Access Compliance Report Public Rights-of-Way (Curb Ramps)

Main Street: NEWPORT_AVE Cross Street: SMOKE_TREE_LN Location: E

ADA ID: RPAT211018095935 Ramp Type: Type 1 - Perpendicular Diagonal Initial Pass/Fail: Fail Overall Compliance: No Severity Score: 5

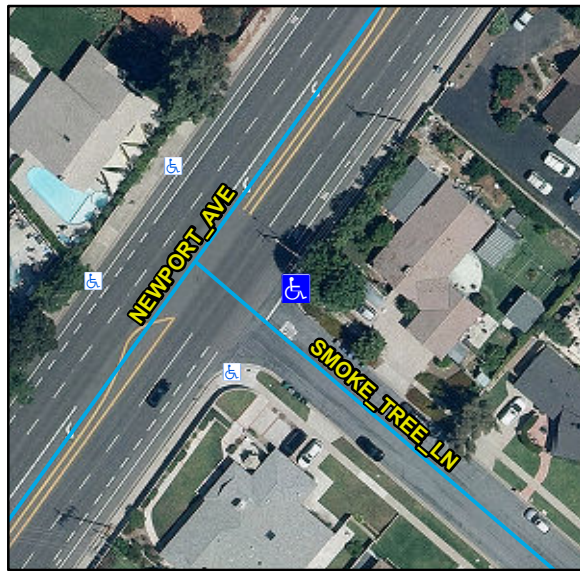
R304.2.2, R304.5.1, R304.5.3, STD 1115

Compliance	Description	Data	Compliance	Description	Data
N/A	Ramp Length (in)	99	N/A	Flare Type LT	
No	Ramp Width (in)	47			N/A
Yes	Ramp Run Slope (%)	3.5	N/A	Flare Slope LT (%)	N/A
No	Ramp Cross Slope (%)	3.9	N/A	Flare Traversable LT	N/A
N/A	Landing Present	N/A	N/A	Flare Type RT	
N/A	Landing Length (in)	N/A			N/A
N/A	Landing Width (in)	N/A	N/A	Flare Slope RT (%)	N/A
N/A	Landing Run Slope (%)	N/A	N/A	Flare Traversable RT	N/A
N/A	Landing Cross Slope (%)	N/A	N/A	DWS Provided	N/A
N/A	Landing Movement Obstructed?	N/A	N/A	DWS Contrast	N/A
	Landing Movement Type	N/A	N/A	DWS Length (in)	N/A
N/A	Landing Shared	N/A	N/A	DWS Full Width	N/A
N/A	Clear Space	Yes	N/A	DWS Offset Left (in)	N/A
N/A	Clear Space To Crosswalk (in)	N/A	N/A	DWS Offset Right (in)	N/A
N/A	Marked Crosswalk 1	No	N/A	Marked Crosswalk 2	No
	Crossing 1 Direction	NW		Crossing 2 Direction	SW
	Marked Crosswalk 1 Width (in)	N/A		Marked Crosswalk 2 Width (in)	N/A

N/A	Ramp Inside Crosswalk 1	N/A	Yes	Ramp Inside Crosswalk 2	N/A
	Crossing 1 Slope (%)	9.6		Crossing 2 Slope (%)	1.7
	Crossing 1 Cross Slope (%)	0.9		Crossing 2 Cross Slope (%)	5.1
N/A	Gutter Ponding	N/A	No	Curb Slope	11.7
Yes	Gutter Lip Height (in)	0		Road Run Slope (%)	3.4
N/A	Gutter Run Slope (%)	N/A		Road Cross Slope (%)	5.7
N/A	Gutter Cross Slope (%)	N/A			
Yes	Overall Surface Condition: Acceptable		Yes	Perp Joint Present	Yes
	Cross Gutter Present?	No		Spandrel Present?	No
	Replace Cross Gutter?	N/A		Replace Spandrel?	N/A

Remove & Replace Curb Ramp With Two New Directional Ramps or Equivalent.
